Montgomery County Historic Preservation

Staff Report

<p>ADDRESS: 7204 Spruce Avenue, Takoma Park</p> <p>RESOURCE: Takoma Park Historic District</p> <p>APPLICANT: Nick Mitchell; (Rick Vitullo, Architect)</p> <p>REVIEW: HAWP</p> <p>CASE NO. 1155550</p> <p>PROPOSAL: Construction of new rear screened porch with skylights and chimney, construction of new side stoop and stairs, and fenestration alterations</p>	<p>MEETING DATE: 5/13/2026</p> <p>REPORT DATE: 5/6/2026</p> <p>PUBLIC NOTICE: 4/29/2026</p> <p>TAX CREDIT ELIGIBLE: No</p> <p>STAFF: Devon Murtha</p>
--	--

Figure 2: Proposed site plan (left) and rendering (right) showing new screened porch.

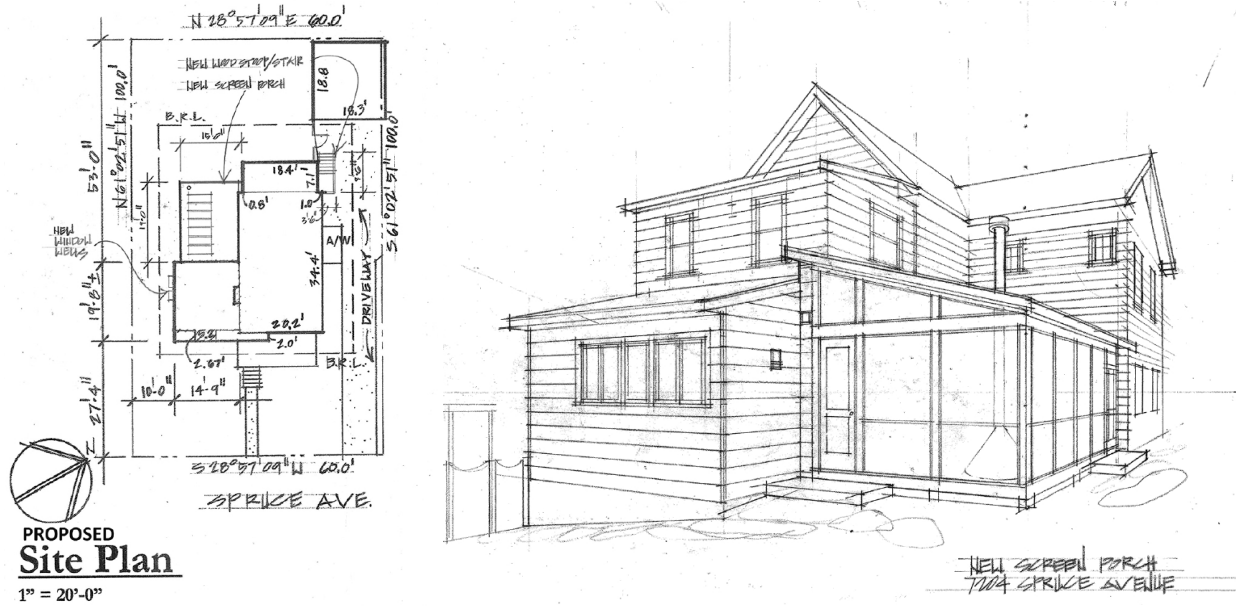
Staff finds that the proposed massing and placement of the screened porch is appropriate. Consistent with the *Guidelines*, the additions will be located at the rear of the existing structure for limited visibility. The addition will be obscured from view by the two-story addition connected to the left (south) of the historic house. This screened porch will be visible from some vantage points along Spruce Avenue (*Figure 6*); however, Staff finds that it is set back substantially, and that the overall character is compatible with the historic resource, per the *Guidelines* and the *Standards*. The proposed materials, including asphalt shingles, wood decking, and wood framing are consistent with the existing materials. The porch will also include a small chimney and seven (7) skylights, which will be minimally visible from the right-of-way and generally do not detract from the overall character of the resource.

Figure 3: Proposed left side (south) elevation

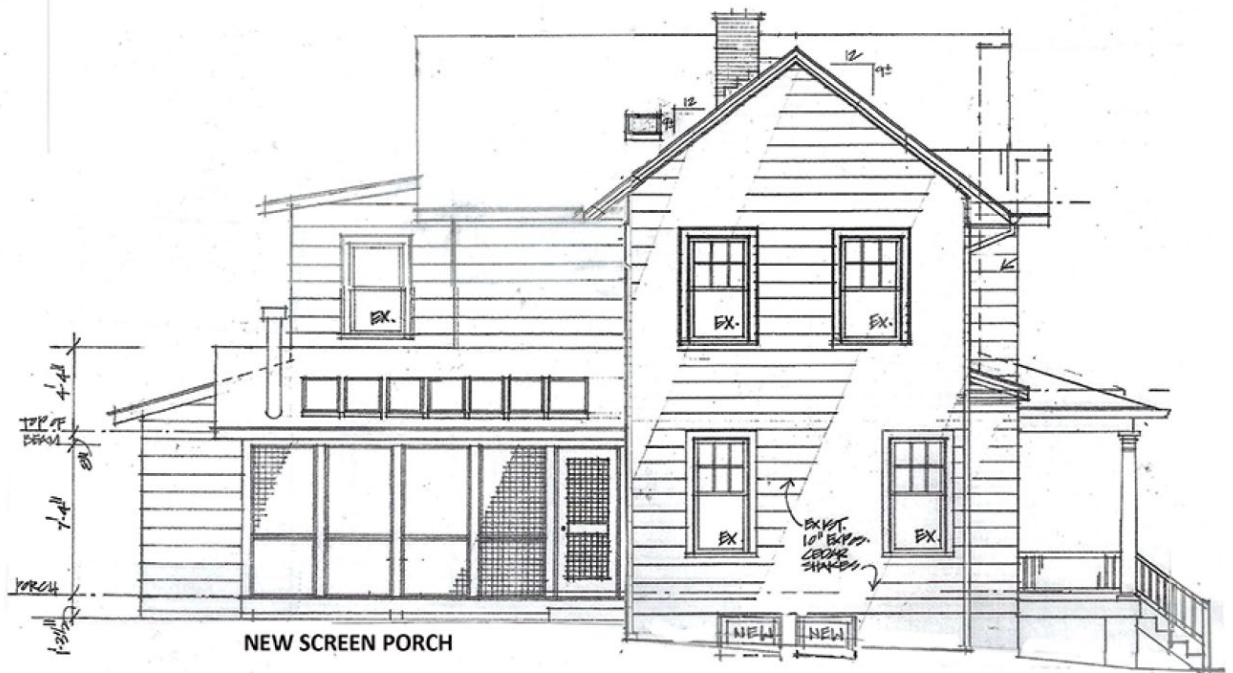
Staff finds that the fenestration alterations will have a minimal impact on the resource. Per *Standard 2*, no historic fabric will be destroyed. The majority of fenestration alterations will be to non-historic additions located at the rear of the property, and will have limited, or no, visibility from the right-of-way. Staff finds that the proposed aluminum-clad windows and door are compatible with the character of the resource, per the *Guidelines*. The subsills will be a PVC material, which Staff finds to be appropriate given that they will not be visible from the street and no historic material will be removed. The non-historic French doors on the historic section of the house will be replaced with new aluminum-clad bifold doors. This alteration will be completely hidden by the new screened porch and the two-story addition.

Figure 4: Proposed rear (west) elevation and partial right side (north elevation).

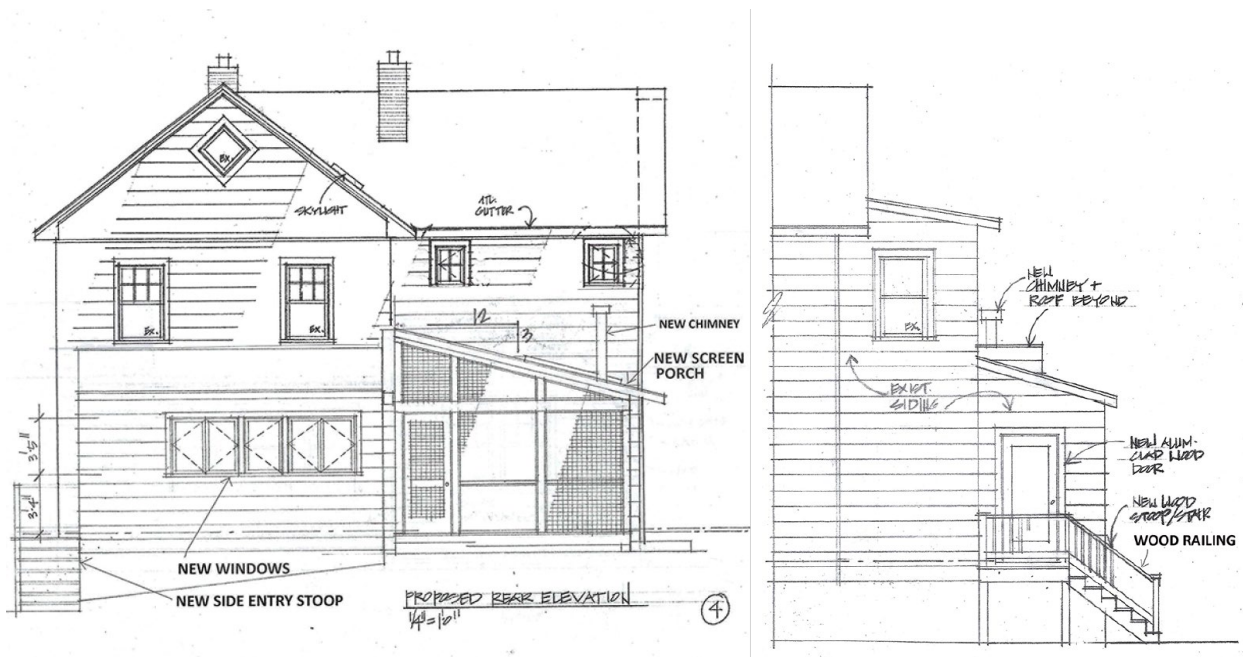
Staff finds that the proposed wood side stoop and stairs are also appropriate. Although visible from the right-of-way, they will be setback from the street and attached to a non-historic rear addition with minimal impact on the resource. Per the *Standards* and the *Guidelines*, this alteration is reversible and compatible with the overall character of the resource. Staff notes that there was a wood stoop in this exact location at the time of designation (c. 1990).
